**FINDINGS AND RECOMMENDATION
OFFICE OF PLANNING AND ZONING
ANNE ARUNDEL COUNTY, MARYLAND**

CASE NUMBER: 2024-0226-V

REQUEST

SITE PLAN

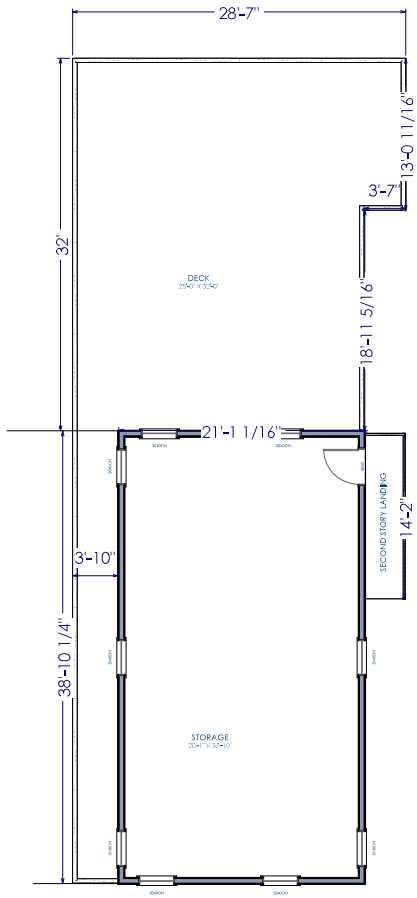
§ 18-4-701 of the Anne Arundel County Zoning Ordinance provides that an accessory structure eight feet in height or greater in an R5 District shall be set back a minimum of 40 feet from the

front lot line. The proposed accessory structure would be constructed 19.2' from the front lot line, necessitating a variance of 21 feet.

§ 18-2-204(b) provides that an accessory structure may not be located in the front yard of a nonwaterfront lot. The proposed accessory structure would be located 19.2' from the front lot line, while the principal dwelling is located 30 feet +/- from the front lot line, necessitating a variance to allow an accessory structure in the front yard 11 feet closer to the front lot line than the facade of the existing principal structure.

§ 18-2-204(d) provides that the floor area of an accessory structure may not be greater than the floor area of the principal structure. The total area of the proposed two-story accessory structure (excluding porches and decks) would be 2,584.35 square feet. The total floor area of the principal dwelling is currently 1,724.2 square feet, necessitating a variance of 860.15 square feet.¹

§ 18-4-701 limits the height of an accessory structure in an R5 District to 25 feet or the height of the principal structure, whichever is less. The existing principal dwelling is 15.3 feet high as is the proposed dwelling addition. The proposed accessory structure would be 21.46 feet high, necessitating a variance of 6.16 feet.

The **Office of Inspections and Permits Engineering Division** took no position on the variance request, but provided the following instructions for the applicant if the variance is approved. At Grading Permit/Standard Grading Plan, show and label the sewer cleanout at the right-of-way and within the property. If sewer needs to be rerouted, show the proposed sewer location.

Based upon the standards set forth in § 18-16-305 of the Code under which a variance may be granted, this Office recommends **denial** of the proposed zoning variances.
